Nine Mile Point  
Nuclear Station

SUBJECT: Nine Mile Point Unit 2  
Docket No. 50-410

License Amendment Request Pursuant to 10 CFR 50.90: Revision of  
Reactor Pressure Vessel Pressure-Temperature Limits

### **PROPOSED TECHNICAL SPECIFICATION CHANGES (MARK-UP)**

Figure 3.4.11-1 (Page 1 of 1)  
Non-Nuclear System Leakage and Hydrostatic Testing Curve

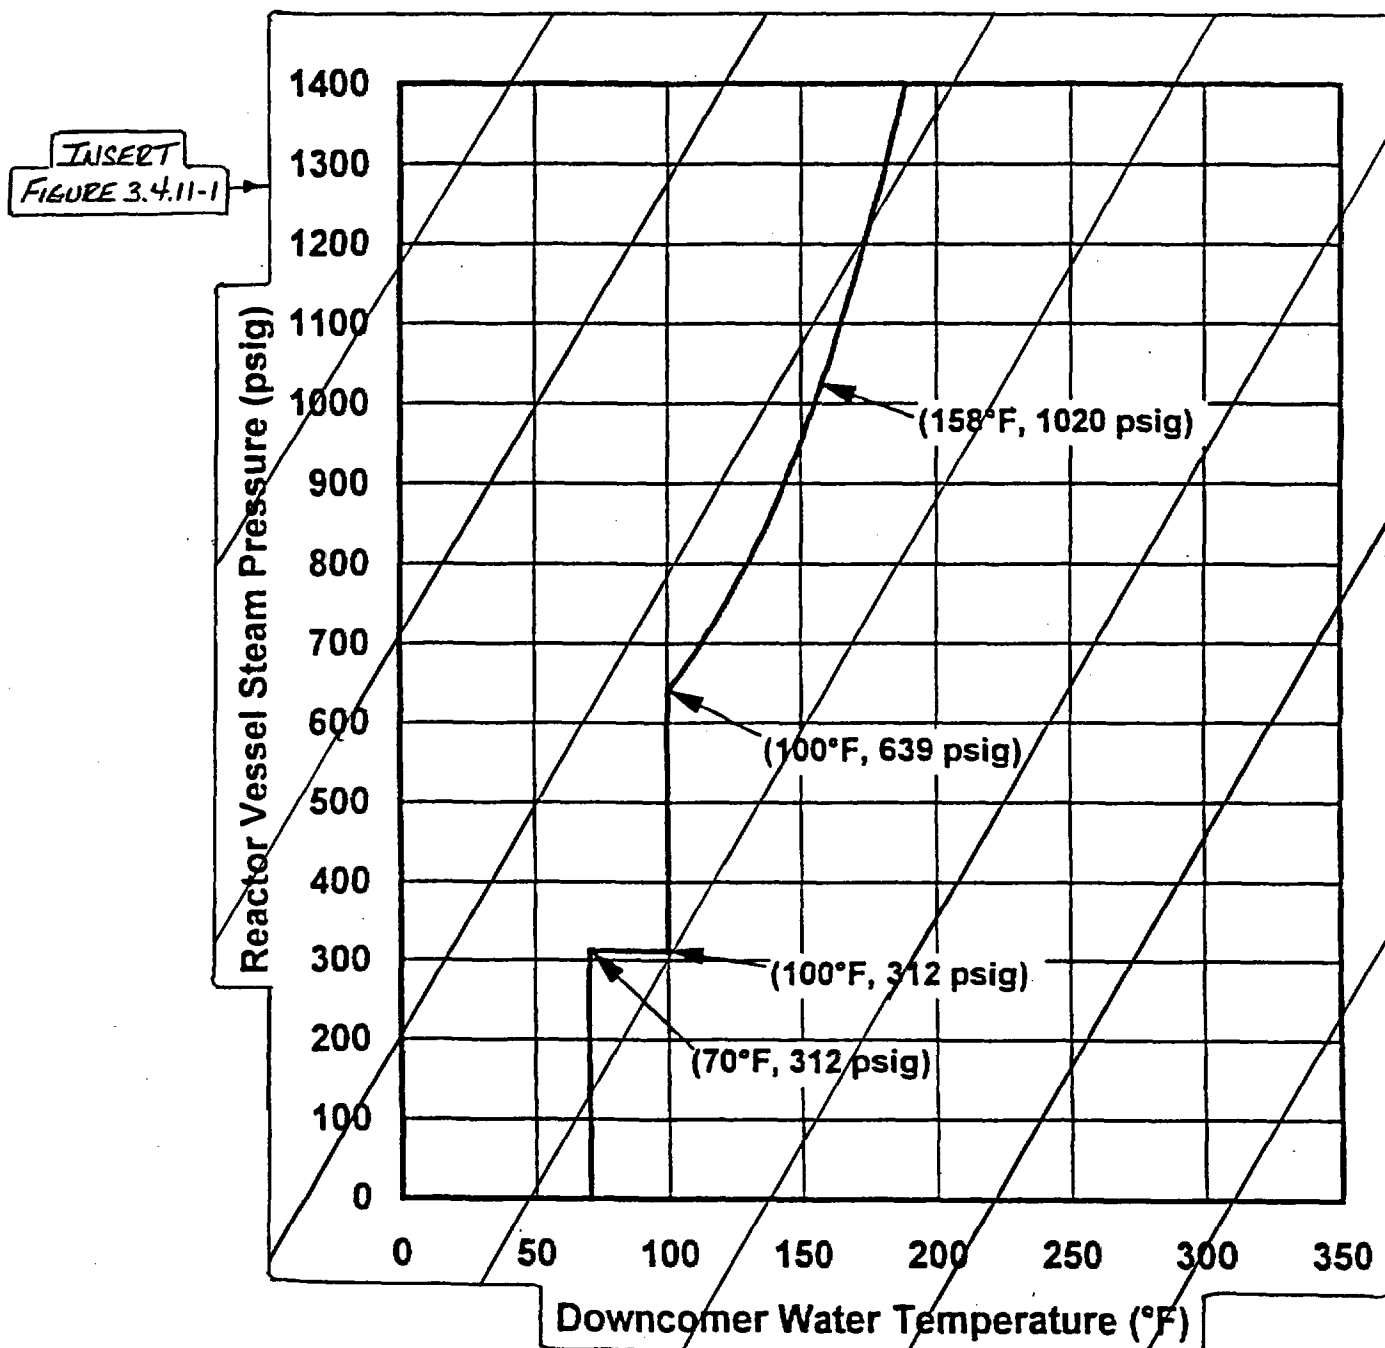
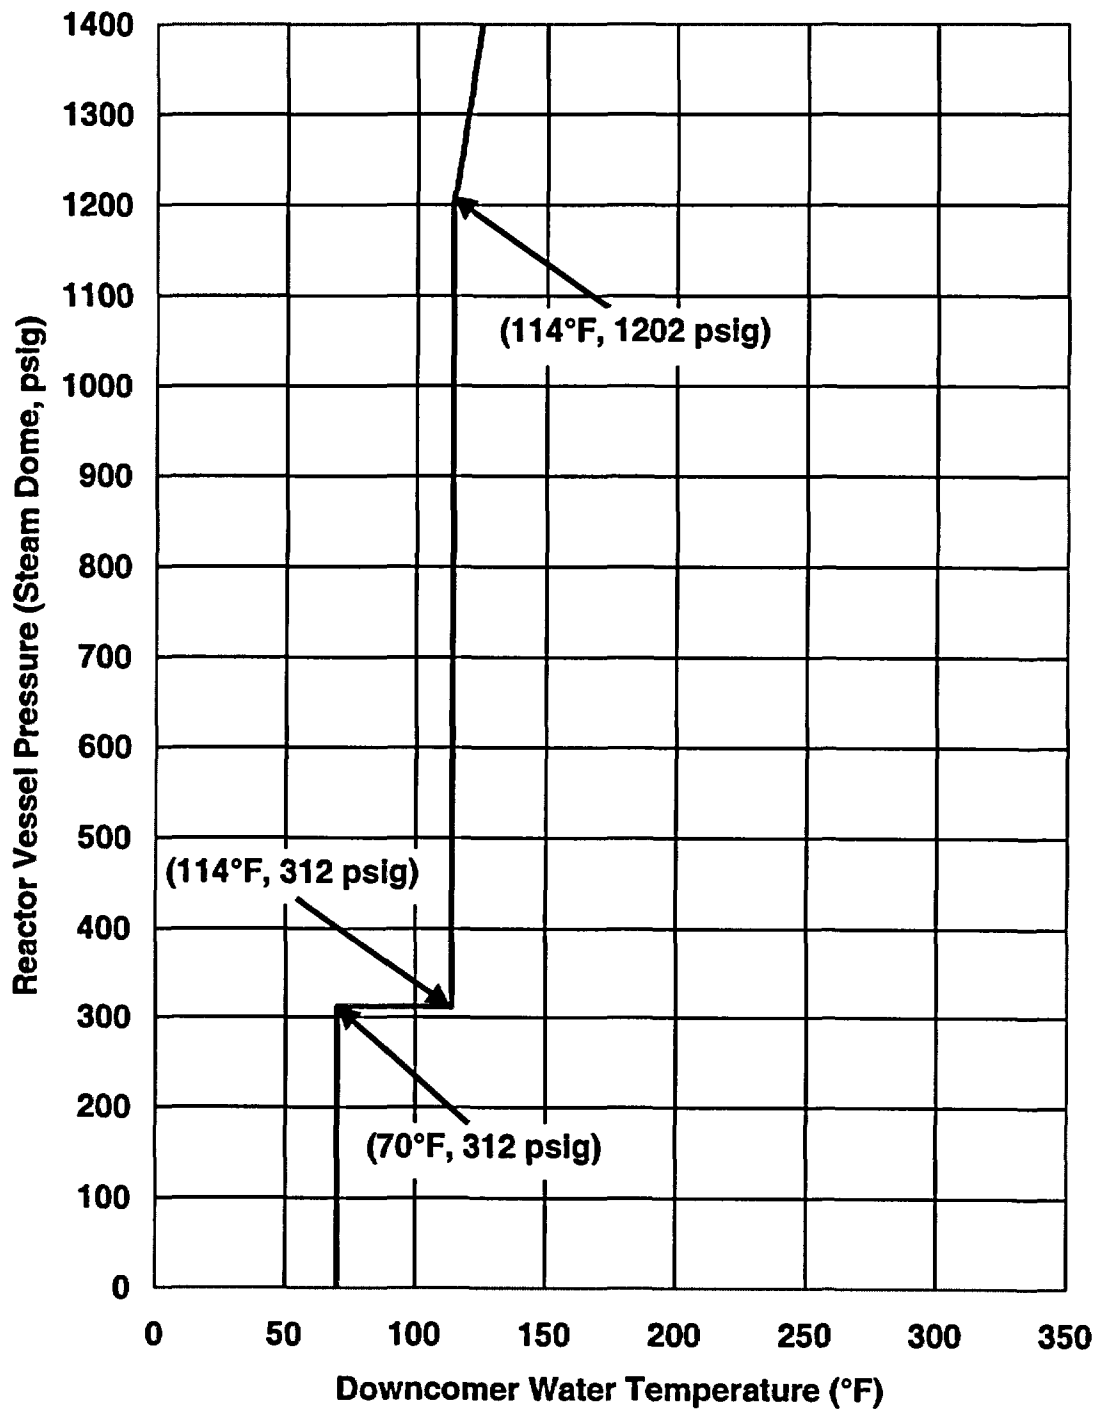
TS Figures 3.4.11-1 through 3.4.11-5 are being replaced with new figures to provide revised (recalculated) RCS P-T limit curves. The revised P-T limit curves will be valid for up to 22 EFPY and are applicable to system leakage and hydrostatic testing and RPV heatup and cooldown during reactor core non-criticality (non-nuclear) and criticality (nuclear) conditions.

The current versions of Technical Specification pages 3.4.11-6 through 3.4.11-10 have been marked-up by hand to reflect the proposed changes.

**INSERT FIGURE 3.4.11-1**
